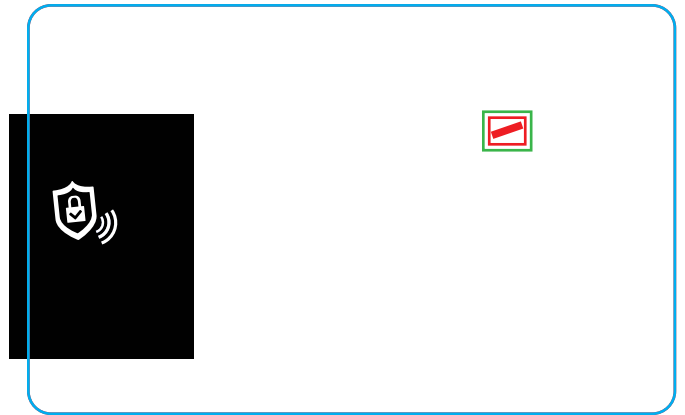
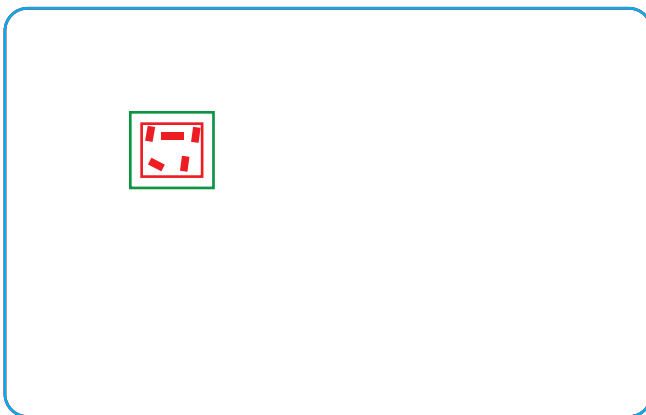
red is the rfid blocking chip area
the rfid blocking chip can't be exact the place,
so we suggest the green area to be white then can cover the rfid blocking chip
